Appl. No. 10/767,599  
Amdt. dated Apr 18, 2005  
Reply to Office action of Mar 24, 2005

**Amendments to the Drawings:**

### REMARKS/ARGUMENTS

FIG 2

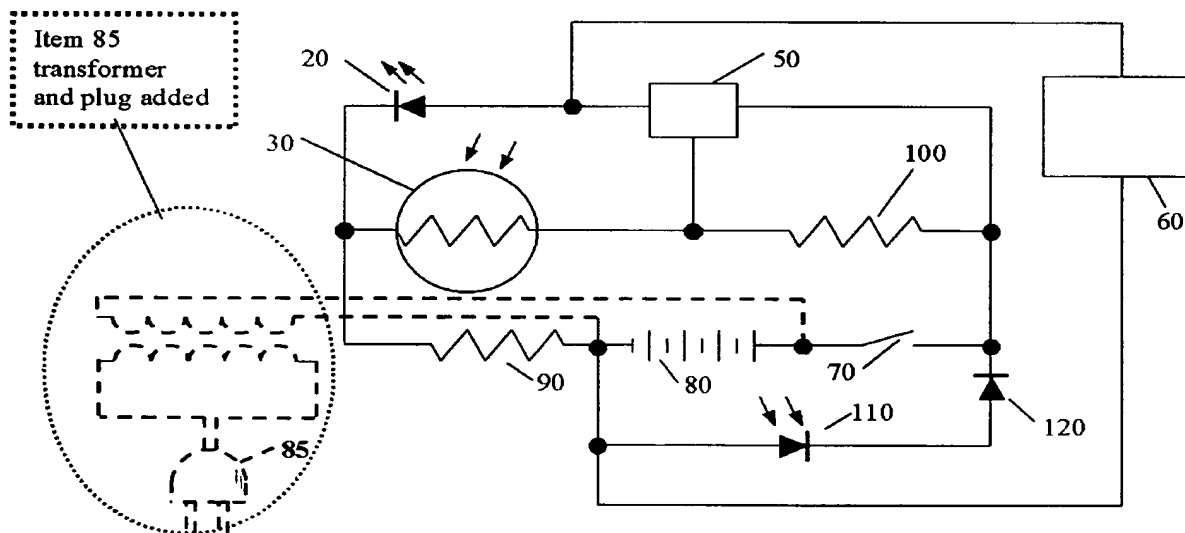
The attached sheet of drawings includes changes to Fig. 2. This sheet, which includes Fig. 1-2, replaces the original sheet including Fig. 1-2. In Figure 2, item 85 all outlet plug has been added.

Figure 2 was modified to show the external power plug. This was performed by including item 85 in the figure and was supported in the claims.
